Safety Evaluation Report

Renewal of the Facility Operating License for the
University of California-Davis McClellan Nuclear
Research Center TRIGA Research Reactor

License No. R-130
Docket No. 50-607

November 21, 2022

Figure 2-1 UCD MNRC Operating Core Configuration

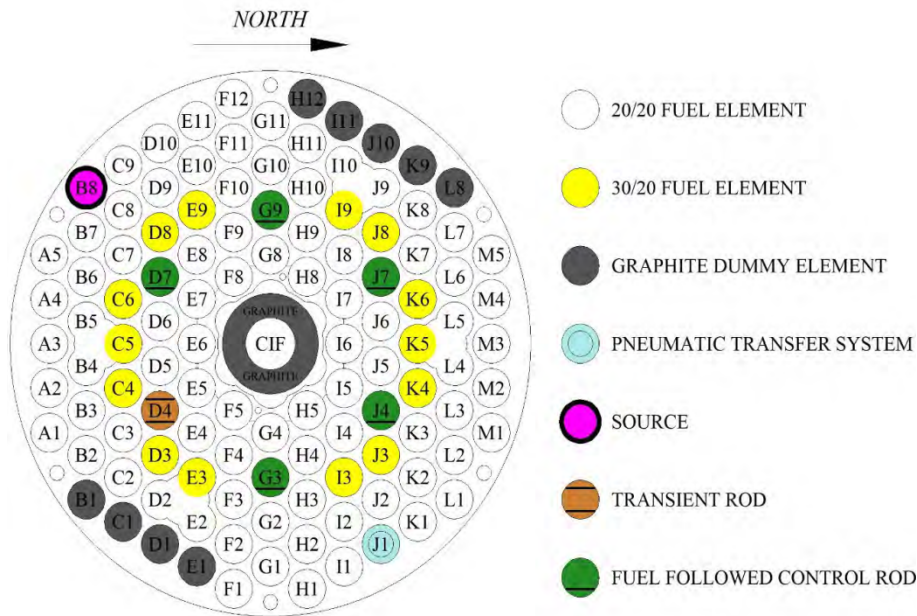
SER Figure 2-1, "UCD MNRC Operating Core Configuration," above was reproduced from the UCD LRA SAR Figure 4.33, "OCC's fuel map," to provide the licensee's OCC, illustrating the locations of the 20/20 and 30/20 fuel elements, graphite dummy element, transient rod (no longer used as a transient rod as result of the elimination of pulsing and square wave operation, but used as a shim rod), fuel follower control rods, the pneumatic transfer system, and the source.

Figure 2-2 UCD MNRC OCC Power Distribution at 1.1 MWt

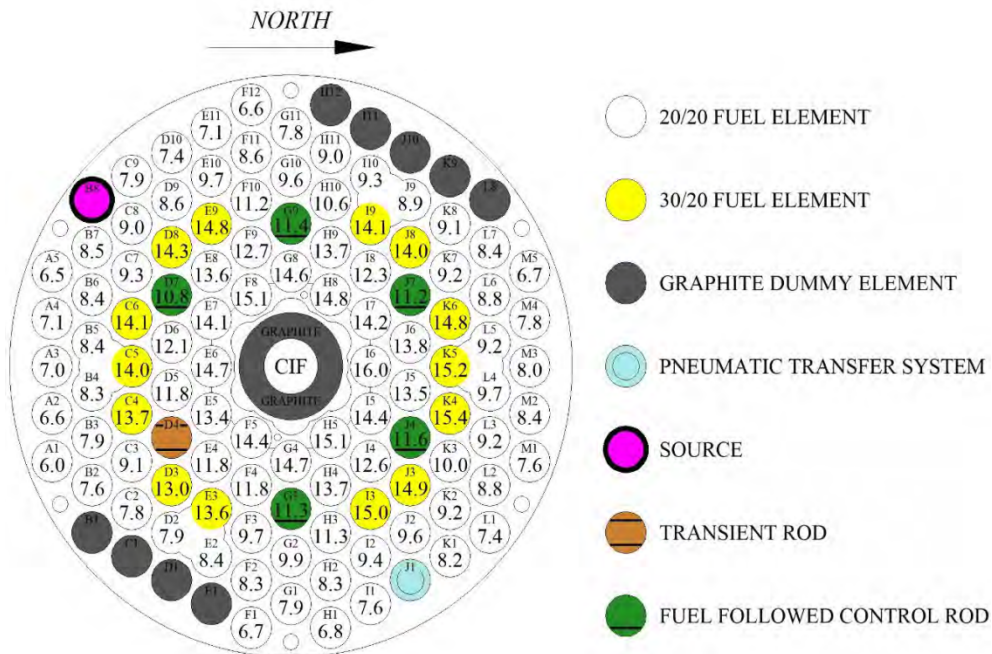
SER Figure 2-2, "UCD MNRC OCC Power Distribution at 1.1 MWt," above was reproduced from the UCD LRA SAR Figure 4.35, "OCC's power distribution at 1.1 MWt," to provide the power distribution for the OCC at 1.1 MWt operation.

Figure 2-3 UCD MNRC LCC Power Distribution at 1.1 MWt

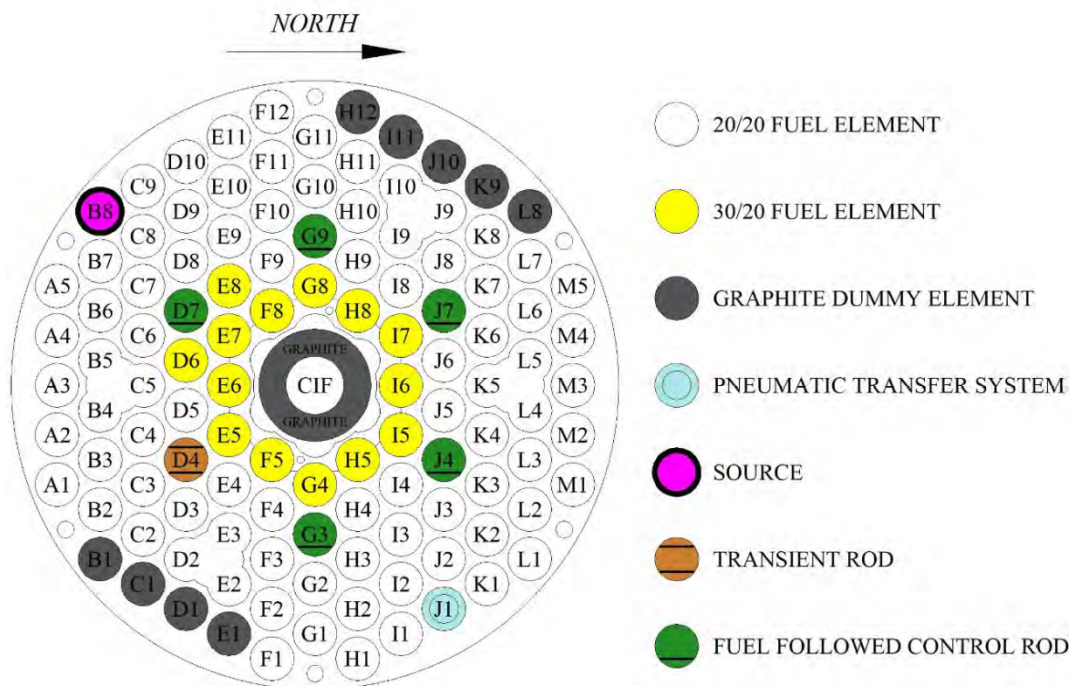
SER Figure 2-3, “UCD MNRC LCC Power Distribution at 1.1 MWt,” above was reproduced from the UCD LRA SAR Figure 4.36, “CC’s fuel map: (14) 30/20 type fuel elements are relocated to 12 positions in C-hex[agonal ring] and 2 positions in D-hex[agonal ring],” to show the LCC at 1.1 MWt operation.

The NRC staff finds that the licensee has provided reasonable assurance that the LCC peak fuel element power, as limited by proposed TS 4.1.4, “Fuel Parameter,” Specification 3, to 17.69 kilowatt (kW), (evaluated by the NRC staff in SER section 5.4.1.4 and found acceptable) will bound all planned reactor operating conditions. This finding is based on justification and validation of the licensee’s analysis methods, the licensee’s method of developing the LCC core discussed above, including consideration of fuel burnup and planned fuel acquisitions, and the restrictions put in place by proposed TS 5.3.1. For the NRC staff’s evaluation of the peak fuel element power of 17.69 kW, see SER section 2.6, which was evaluated by the NRC staff and found acceptable.

Figure 6.1 UC Davis McClellan Nuclear Research Center Organization for Reactor Operation, Licensing, and Safety

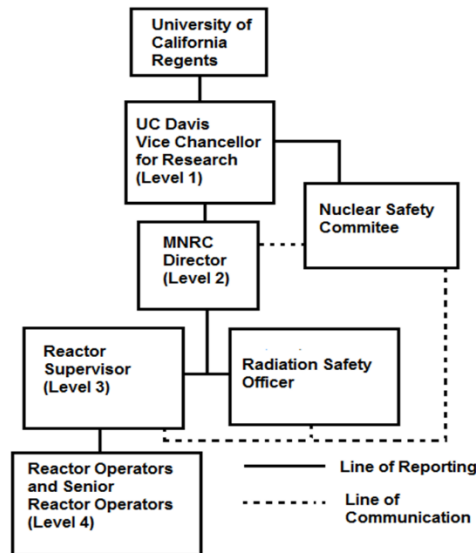
The NRC staff reviewed proposed TS 6.1.1 and finds that it is consistent with the guidance in NUREG-1537, Part 1, appendix 14.1, section 6.1.1, “Structure,” and ANSI/ANS-15.1-2007, section 6.1.1, “Structure,” which states, that the structure should follow the guidance in Figure 1 - Organization chart. Based on the information above, the NRC staff concludes that proposed TS 6.1.1 is acceptable.
